## Product Updates in Cartridge Oil Filters

# CONSTRUCTION UPDATE

Previous design sealing example

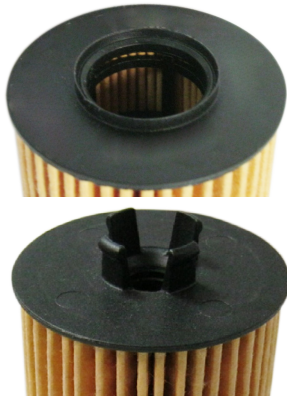
The 51370, 57213, 57214, 57215, and 57311 use a design that incorporates skirted endcaps and a free floating bypass valve that uses the O.E. spring load in the housing standpipe.

Updated skirted endcaps

Updated Nitrile sealing

O.E.S filter and end cap

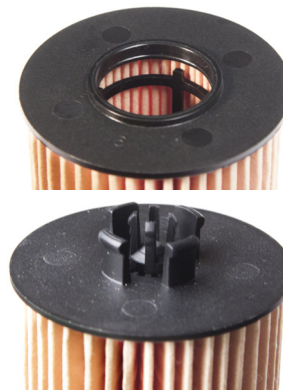
The 57526 and 57674 feature updates including the flat end caps, updated center tubes, and integral seals.

The most notable change is the uses of the O.E. spring load housing standpipe to close and load a newly designed valve plug that snaps into the top end cap.

Our updated end cap with new bypass valve

Free floating Bypass Valve
